Marine Scotland - Licensing Operations Team **Scoping Opinion**

**SCOPING OPINION FOR THE PROPOSED SECTION 36 CONSENT AND
ASSOCIATED MARINE LICENCE APPLICATION FOR THE REVISED NEART na
GAOITHE CAPE OFFSHORE WIND FARM AND REVISED NEART na GAOITHE
OFFSHORE TRANSMISSION WORKS**

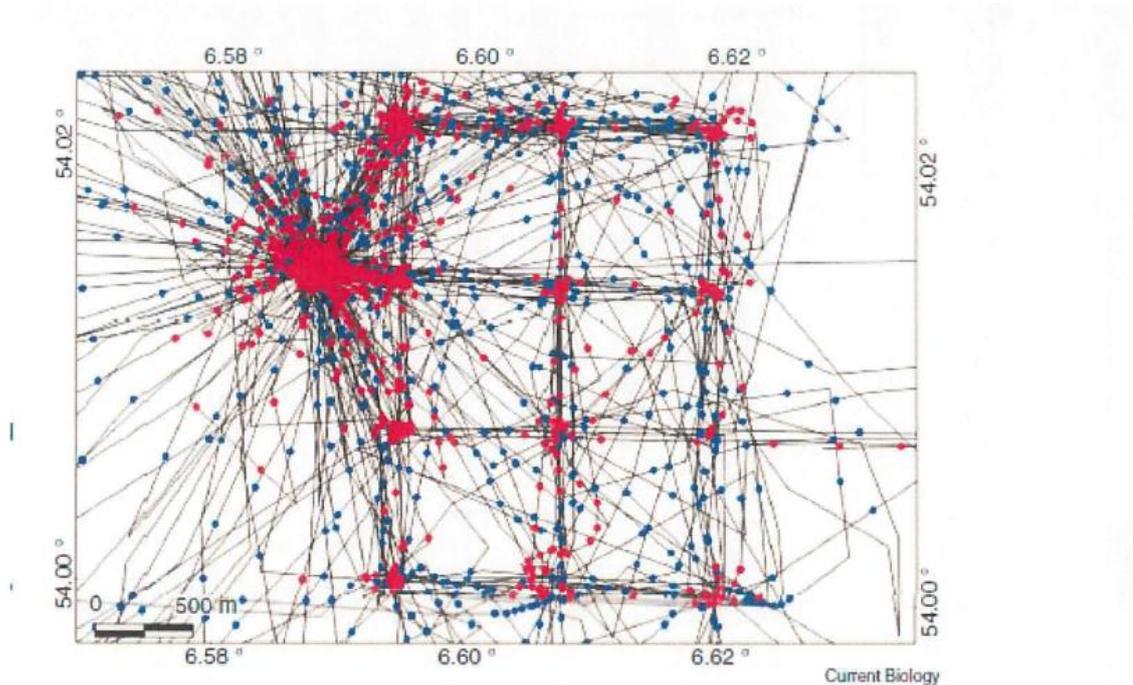
No. New information is now available on how marine wind turbines alter the foraging pattern of seals and may attract them in to areas they would otherwise have passed by and this needs to be considered, see Russell et al (2014). The diagram taken from this paper, below, clearly shows wind turbines to attract seals.

These authors also state: “The finding that a proportion of seals adjust their behaviour to make use of anthropogenic structures raises questions regarding the attributes of these individuals and the ecological consequences of such behaviour.” And “The windfarms considered here are new, and prevalence of such behaviour may increase with time, especially if the artificial reefs are not yet fully established. Even at the levels of prevalence within our sample, this behaviour is likely to be displayed by a larger number of individuals given that the population of Harbour Seals in the North Sea is estimated as 55,000 and 65,000 Gray Seals are estimated to haul out on the British coast of the North Sea alone.”
